One Industrial Complex, Three Permits, No Full Assessment

Nov 25, 2026 · @Juan Corrin on behalf of the Matienzo Caves Project

0. Background: three replies and one authorisation

Figure 1. Sketch of the hill between Matienzo and Riaño (not to scale). Illustrative flow path; altitudes approximate. Matienzo Caves Project.

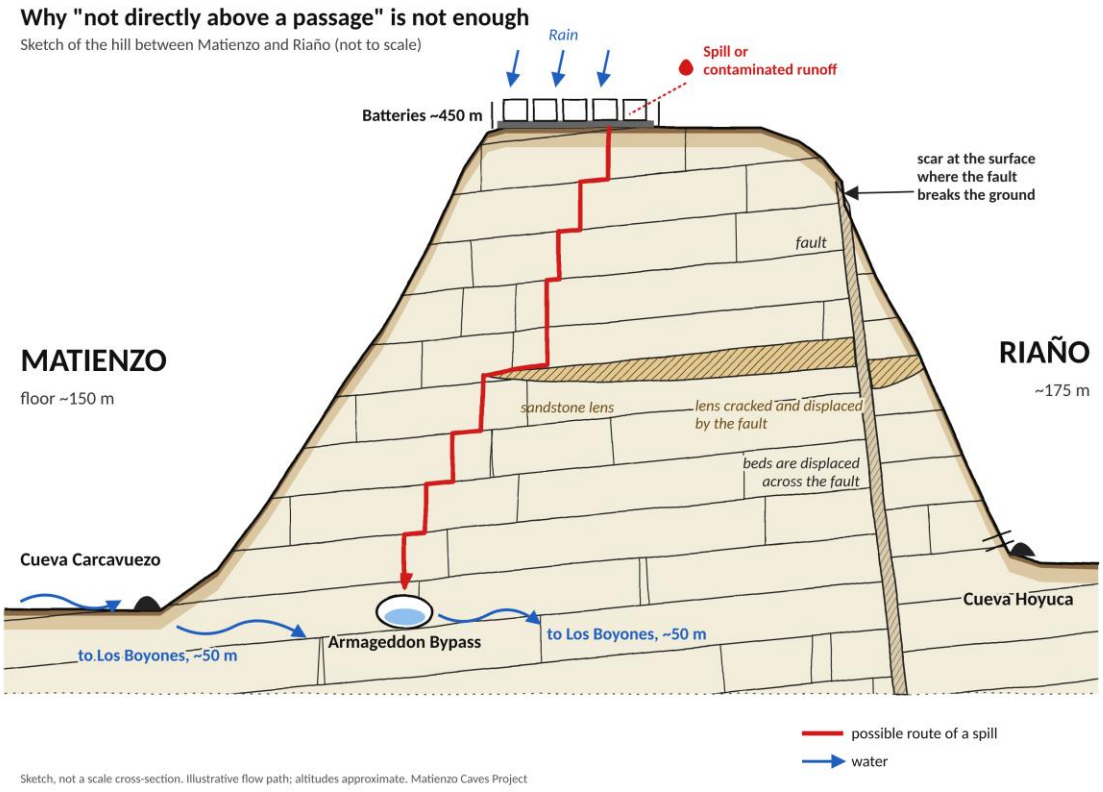
Why overlap is the wrong question. Water, sediment and spilled liquids on a karst hillside do not stay at the surface in pipes and ditches, and they do not drop vertically either. They enter the soil and the weathered upper rock, then follow joints, bedding planes that dip, inclined faults and the contacts between different rock layers. A lens of sandstone can hold water up and send it sideways until it finds a crack. Water reaches the streamway through shafts (avens) and inlet passages, often a long way from where it entered. Figure 1 shows that principle on the hill between Matienzo and Riaño: batteries at about 450 m, the Matienzo floor at about 150 m, Riaño at about 175 m, Los Boyones at about 50 m, and a possible spill route that steps down through the rock, sideways as well as down, to reach the Armageddon Bypass streamway. The footprint does not have to lie above a passage. It has to lie within the area that drains to it.

Figure 2. Underground hydrology of the Four Valleys System (map in Spanish). Blue arrows: explored and surveyed drainage towards Los Boyones. Dashed arrow: connection proved by dye tracing. Red polygon: approximate area of the industrialised zone. Matienzo Caves Project, November 2026.

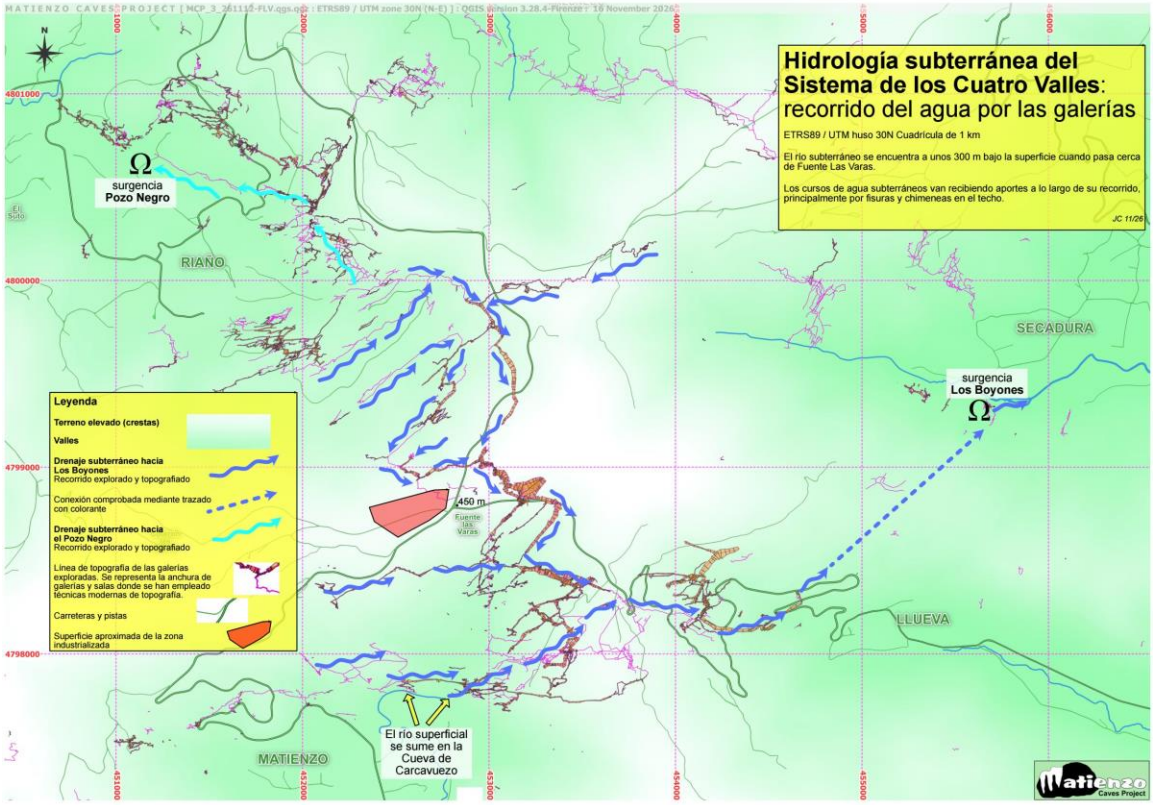
What a cave map shows, and what it does not. A cave survey records passages large enough for people to enter. Water also moves through cracks and conduits too small to enter. The MCP map (Figure 2) shows underground streams receiving water along their whole course, mainly through fissures and shafts in the roof. The survey plan in Figure 3 overlays the BESS Cantabria 1 layout on the surveyed passages: the Armageddon Bypass passes beneath the adjoining BESS Solórzano and collector substation platform and close to the Cantabria 1 plot. Several of its inlets and avens have not yet been climbed. Further exploration of that passage is planned for December. A claim of "no overlap" is a claim about the part that has been explored.

The missing test. The method for showing where water from a site goes is dye tracing. The MCP's map (Figure 2) already shows one traced connection to Los Boyones, so the method is routine in this system. No trace has been carried out from the Fuente Las Varas site, and none has been proposed. The promoter's reply that the MCP "has not demonstrated" a connection asks us to do the tracing that the assessment should have done.

Figure 3. Survey of the passages under Fuente Las Varas with the BESS Cantabria 1 layout and the collector substation platform superimposed. Matienzo Caves Project, November 2026.

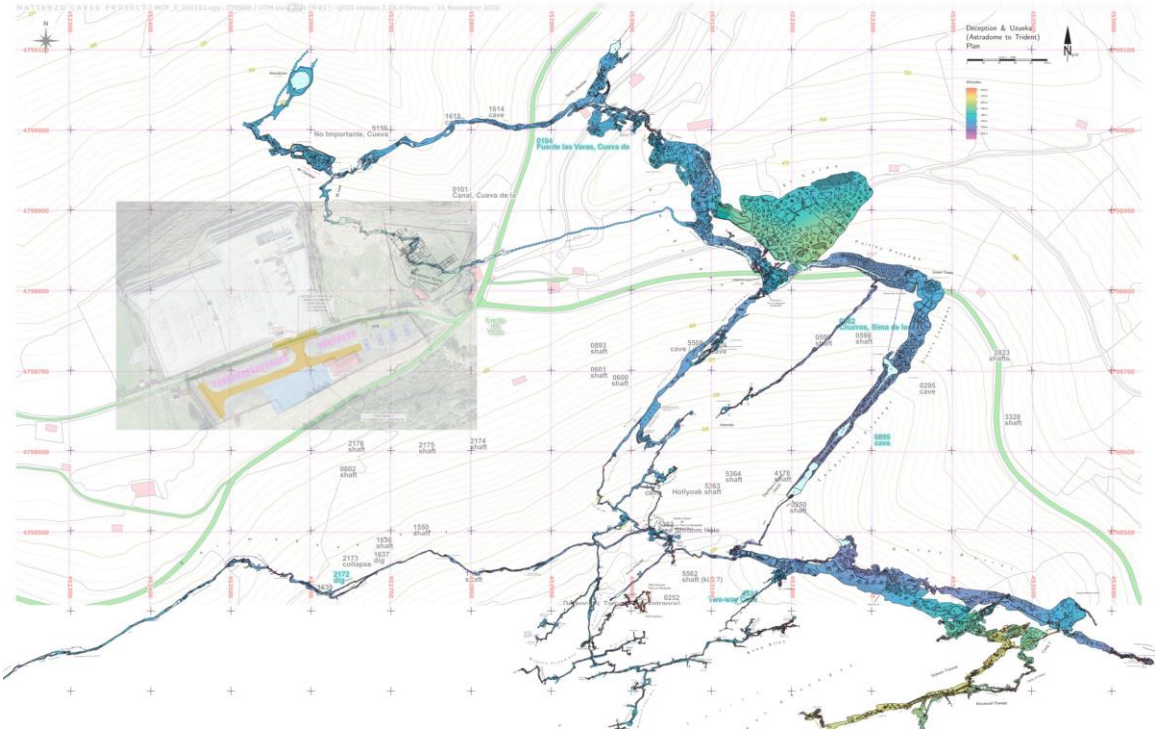
The promoter's main technical argument, repeated in all three replies, is that the plant does not sit directly above a mapped cave passage. In karst, that is the wrong test.

> *«no presentan superposición directa con las galerías subterráneas cartografiadas»*
>
> *"show no direct overlap with the mapped underground galleries" (Junta reply, Segunda B2; MCP reply, Quinta B6; FCE reply, Tercera)*

> *«sin que ello implique descartar la existencia de posibles conexiones hidrogeológicas subterráneas no identificadas»*

> *"without this implying that the possible existence of unidentified underground hydrogeological connections is ruled out" (Junta reply, Segunda B2)*
